# Memorandum

Subject: Summary Peer Review – Traffic  
Queset Commons – 40R Development

RE: Response to Traffic Peer Review Comments  
Quset Commons - 40R Development

Subject: Peer Review – Traffic  
Queset Commons – 40R Development  
cc: Mark Bobrowski, Blatman, Bobrowski & Mead LLC  
David Colton, Town Administrator

Exhibit - Uses to be Assigned to Roosevelt Circle

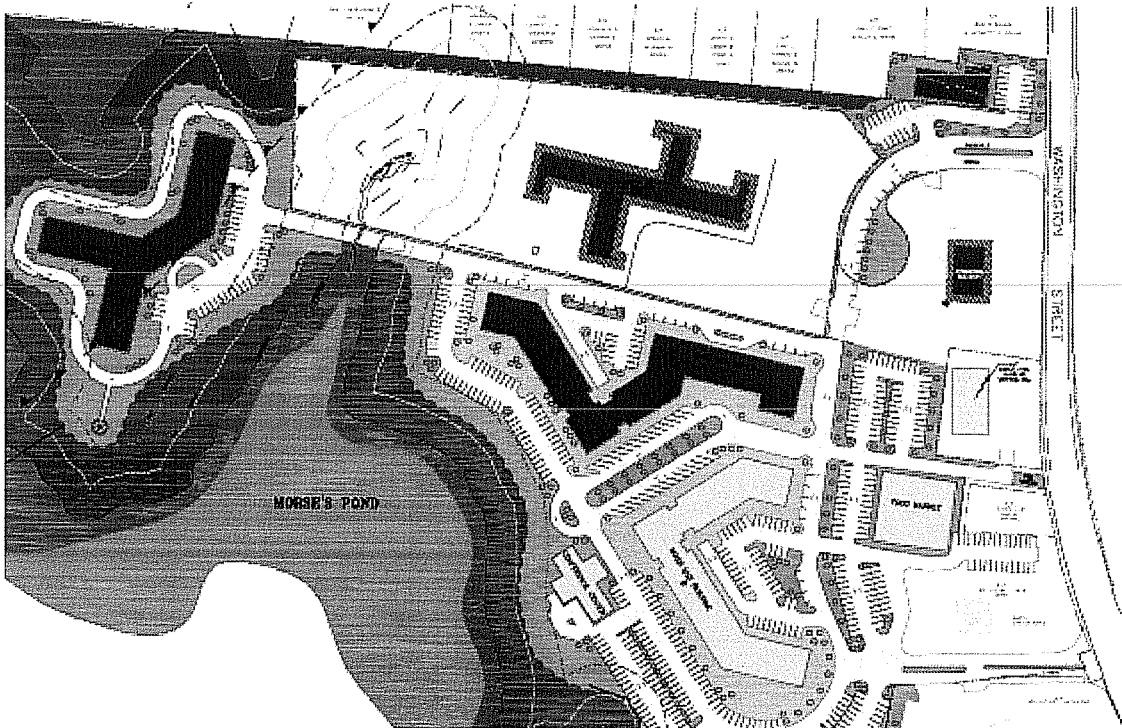
Due to the critical nature of the operating conditions at these locations and the subjective nature of the current trip distribution assignment, we requested that a **“sensitivity analysis”** be performed. This sensitivity analysis was requested to “test” for possible operational issues that may arise from variations in the estimated trip distribution between the two site drives. We requested that the sensitivity analysis be performed to evaluate the site access drives under the following conditions:

- 100% of site traffic assigned to the access drive at Belmont / Washington Street
- Traffic from the components shown in “red” on the Exhibit, which follows, be assigned to Roosevelt Circle, given their proximity to this access drive. The result is the assignment of roughly **45%** of entering vehicles and **35%** of exiting vehicles to be assigned to Roosevelt Circle.

We received this sensitivity analysis via email on August 21, 2007.

South Easton Savings Bank as Shown on Site Plans

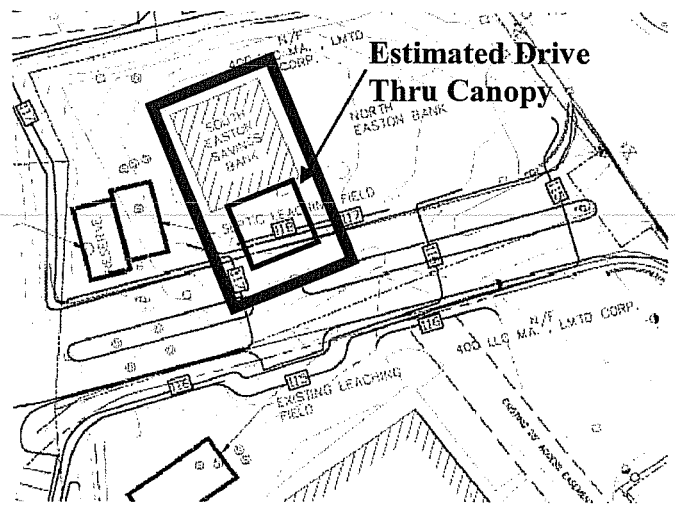
The conceptual site plan provided does not appear to show the current footprint of the South Easton Savings Bank accurately. The drive thru teller lanes and associated building canopy appear to be missing.

The area between the Bank and CVS will be the location of the main access drive to the Development. The existing drive is proposed to be widened to accommodate additional site related traffic. It appears that this widening may encroach upon the drive thru lanes of the bank and maybe the associated overhang. **The existing building footprint of the South Easton Savings Bank should be reviewed and updated, as necessary.**

The revised site plan was presented at the meeting on September 24, 2007.
